June 17, 2016

Dear Chairman Geller and Members of the Zoning Board of Appeals:

When I consider the proposed construction at 40 Centre Street, the current plan fails to mitigate its many potential impacts to pedestrian safety and to emergency vehicle response.

High Density Developments in Coolidge Corner

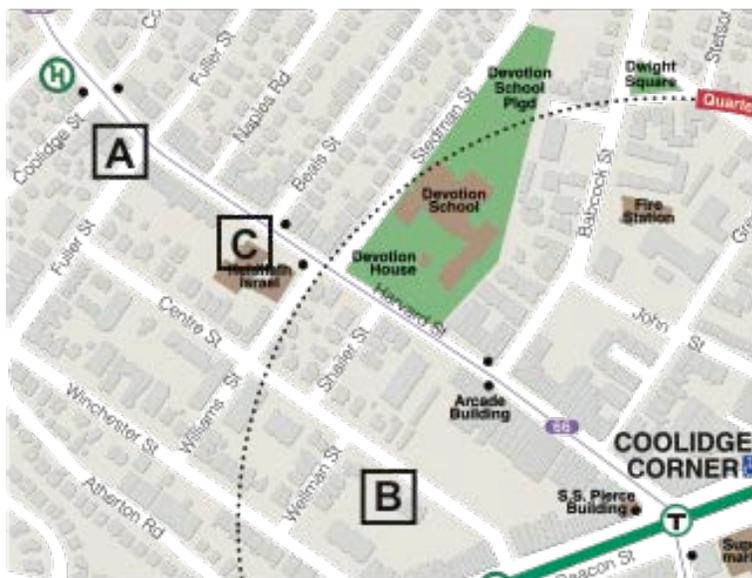
The proposed development plan fails to consider **at least three other pending major construction projects** within blocks of 40 Centre Street. These construction projects would probably coincide with that proposed at 40 Centre. Try to imagine the inevitable increase in traffic congestion during these almost simultaneous demolitions and construction. They would inevitably affect emergency vehicle access along Centre Street, particularly during construction because:

- a) Renovations to the Devotion School on Harvard Street are planned between **July 2016 and May 2018**. This construction may cause traffic diversions to Centre Street, as well as to Winchester Street
- b) The proposed 40 Centre Street construction could create an additional traffic chokepoint, thus diverting east-west traffic to Winchester Street
- c) Construction on Centre Street would necessarily create backups in the turn lanes from Beacon Street to Centre Street

All of this additional traffic congestion could impede emergency vehicle response to the 498 housing units of senior citizens at 100 Centre Street and 112 Centre Street.
